Memorandum

To/Attention	Paul Saik, CET Team Lead, Infrastructure Community Growth & Infrastructure City of Chestermere	Date	January 22, 2021
From	Michael Slattery, P.Eng.	Project No	121935
cc	Centron Group, David Dalen IBI Group, Rod Sieker, Elvin Karpovich		
Subject	Clearwater Park Technical Memorandum Sanitary Servicing - Revised

PRIME CONSULTANT IBI GROUP 3rd Floor – 227 11 Avenue SW Calgary AB T2R 1R9 Canada tel 403 270 5600 fax 403 270 5610 ibigroup.com
FIGURE NAME SANITARY SERVICING LAYOUT PROPOSED TIE-IN TO CITY OF CHESTERMERE LS#10
FIGURE NO. 3.1
OPTION #3

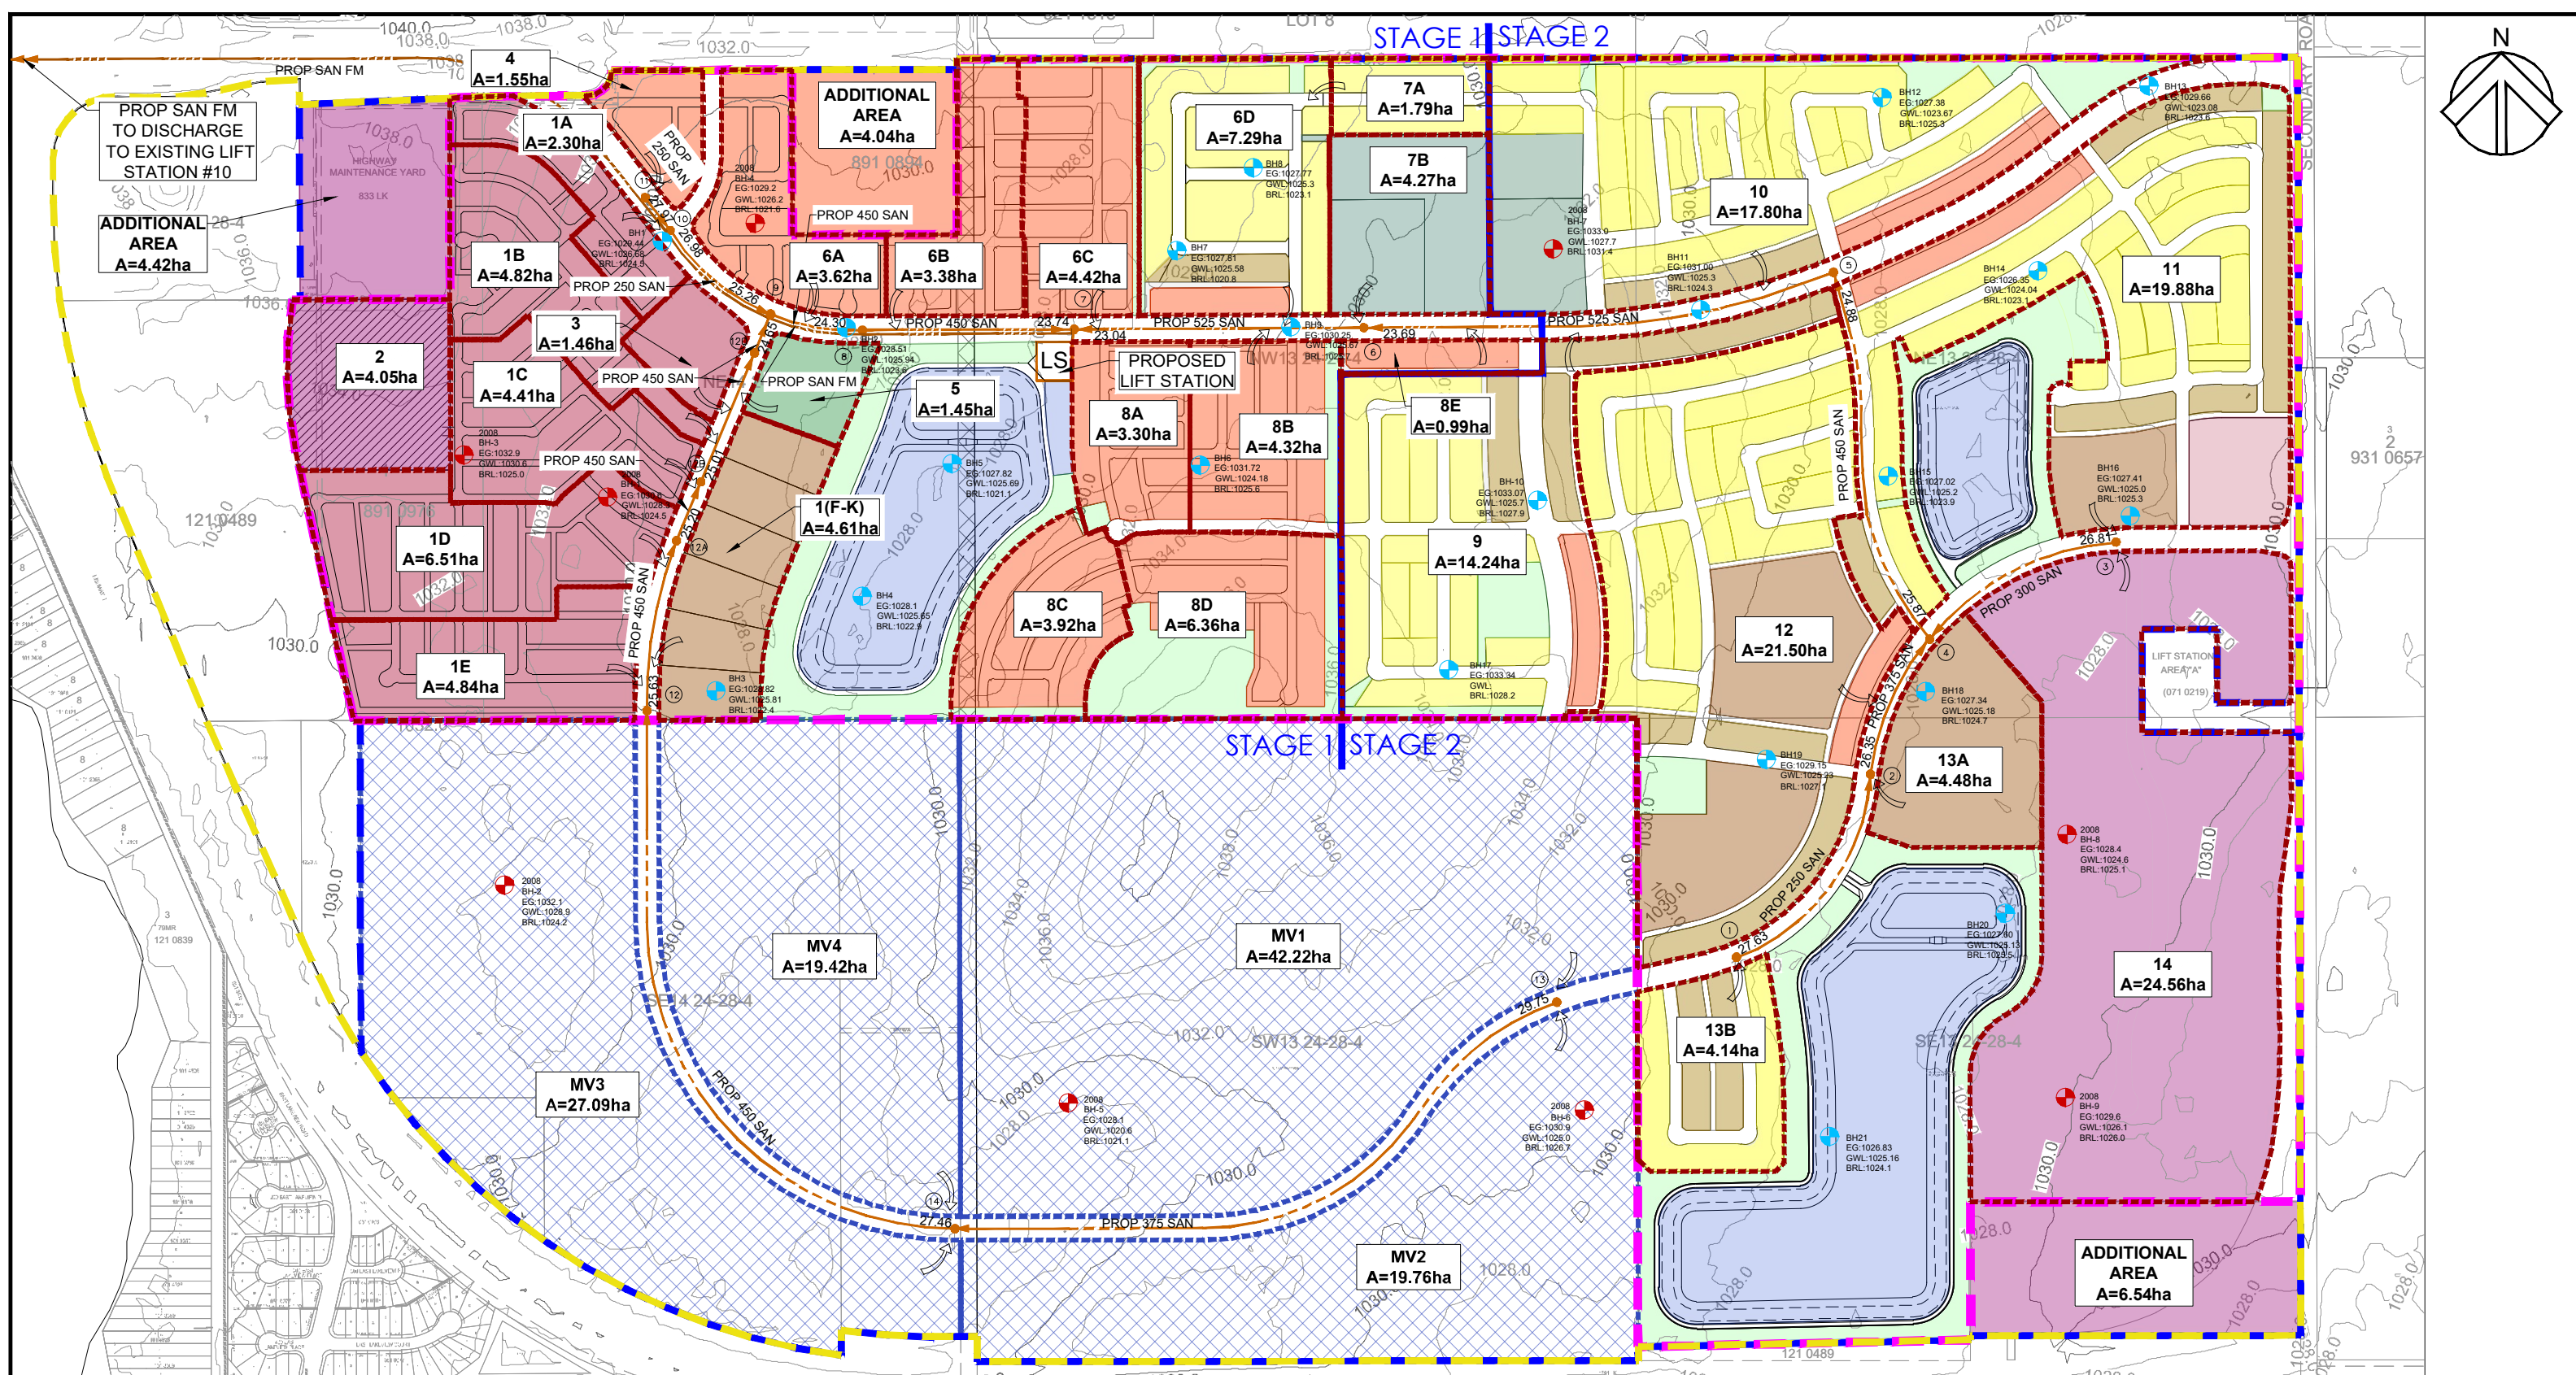
- Page 3 – Please change Option 1 wording - “This option is no longer being considered.”
- Page 3 - Option 2 is worded incorrect – “East Chestermere gravity trunk is to drain to LS #14.”
- The sanitary generation rate can be updated to 250L/c/day.

Land uses and projected population stats for the area are detailed on Figure 3.1 and in the sanitary sewer design flow chart attached (Table 1.0). Population densities used to determine the respective populations based on the proposed land uses were as follows:

The document has been updated in accordance with these comments as well as incorporating the latest statistics from the Land Use and Outline Plan and Area Structure Plan submissions dated January 8th, 2021.

PRIME CONSULTANT IBI GROUP 3rd Floor – 227 11 Avenue SW Calgary AB T2R 1R9 Canada tel 403 270 5600 fax 403 270 5610 ibigroup.com	FIGURE NAME SANITARY SERVICING LAYOUT PROPOSED TIE-IN TO CITY OF CHESTERMERE LS#10
	FIGURE NO. 3.0

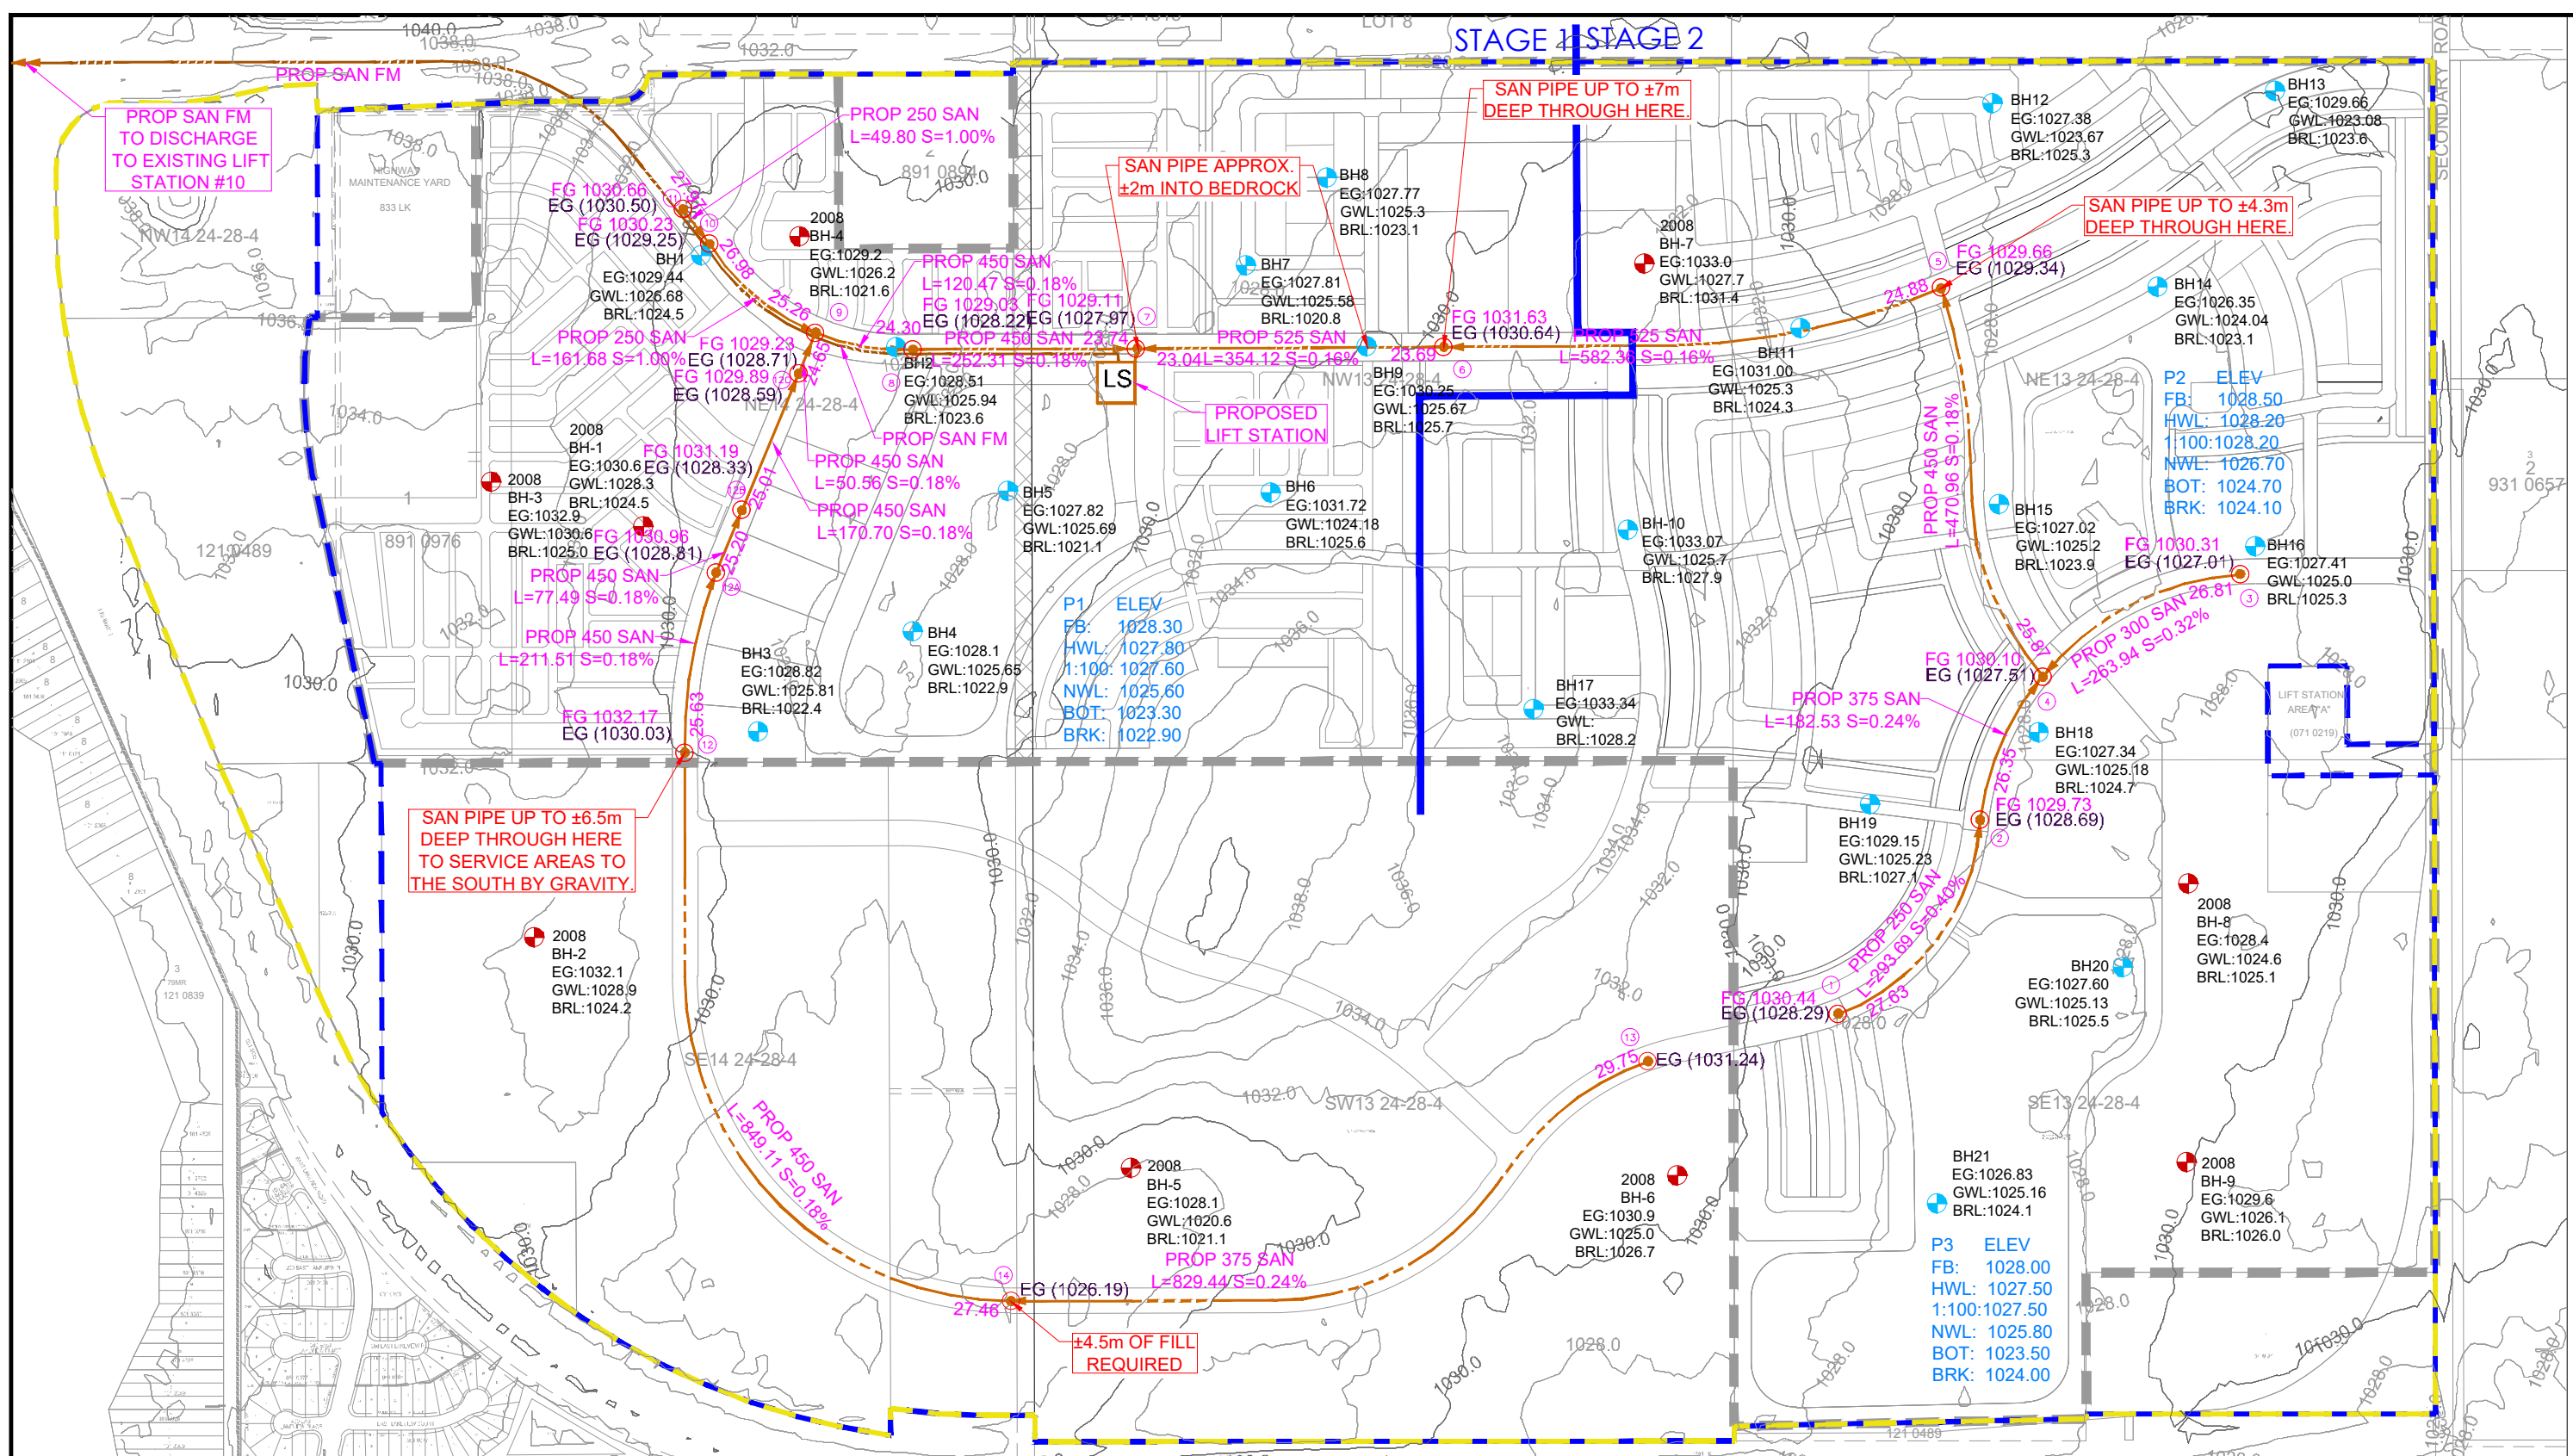
While it is possible to service the entire area with one lift station, there are several challenges that the existing site topography presents. As shown in Figure 3.0, to service the Clearwater Park Stage 2 lands, the pipe sections from manhole 5 to the lift station are between 4.3 and 7m deep. This also places the pipes up to 2m into bedrock around manhole 6 based on nearby borehole information. In the ASP lands to the south, the pipes are up to 6.5m deep at manhole 12, while also requiring up to 4.5m of fill at manhole 14, which is a natural low-lying area.
